Air Conditioning - Filtering Refrigerant After A/C Compressor Replacement - Service Tips

**Article No.
98-12-5**

This TSB article is being republished in its entirety to revise the Service Procedure and to update the model years.

Figure 1 - Article 98-12-5

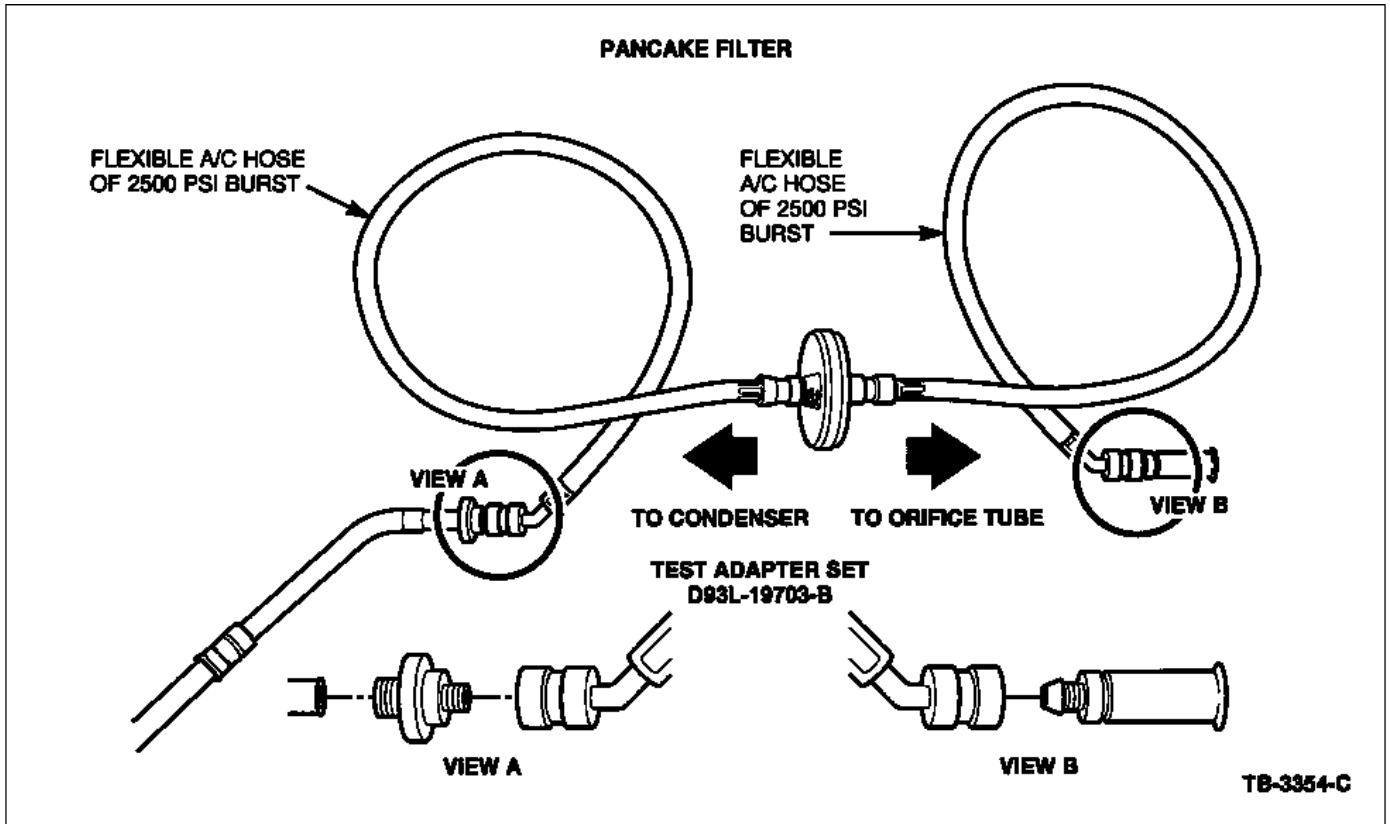
4. Install a new orifice tube. Refer to the Dealer Master Parts Catalog for the correct orifice tube part number. If the orifice tube in the vehicle is located in the liquid line between the condenser and the evaporator, replace the liquid line assembly.
5. Install pancake filter in the liquid line between the condenser and the orifice tube, Figure 1.

- a. Be sure orifice inlet is toward the condenser.
 - b. Connections can be made using Test Adapter Set D93L-19703-B, or equivalent, and flexible refrigerant hose of 2500 psi burst rating. Individual fittings are also available.
6. Remove the old compressor following Service/Workshop Manual procedures. Drain the oil into a calibrated container.
 7. Drain the oil from the replacement compressor into a clean calibrated container.
